Design review report

| Code: | AE-32846 | |

Aim of this document is to describe suggestions and corrections that Telit advises to improve Ovoo Electronics application that integrates a Telit GE910-QUAD V3 module.

Figure. RF Waveguide typical layout.

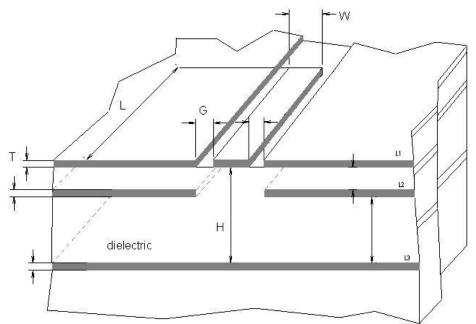
- 2.2.1. General placement
 - ✓ OK
- 2.2.2. RF aspects
 - Your Cellular is not waveguide with correct characteristic impedance of about 50 Ohms. We calculated its characteristic impedance based on the stackup provided on Stack Up (00.00.04).PDF and the CPW model with following dimensions:

The resulting impedance is around 29 Ohm, too low. A suitable waveguide can be obtained using a wider Gap:

If dielectric thickness between 2 consecutive layers, as could be Layer1 and Layer2, is not enough for right impedance realization, then you can remove the copper under RF line or pad, in this case on Layer2, to have wider dielectric between Layer1 and Layer3, as example in figure below.

Track width: 0.77 mmGround Gap on top layer: 0.15 mm

• Dielectric thickness: 1.477 mm (layer 4 to layer 1)
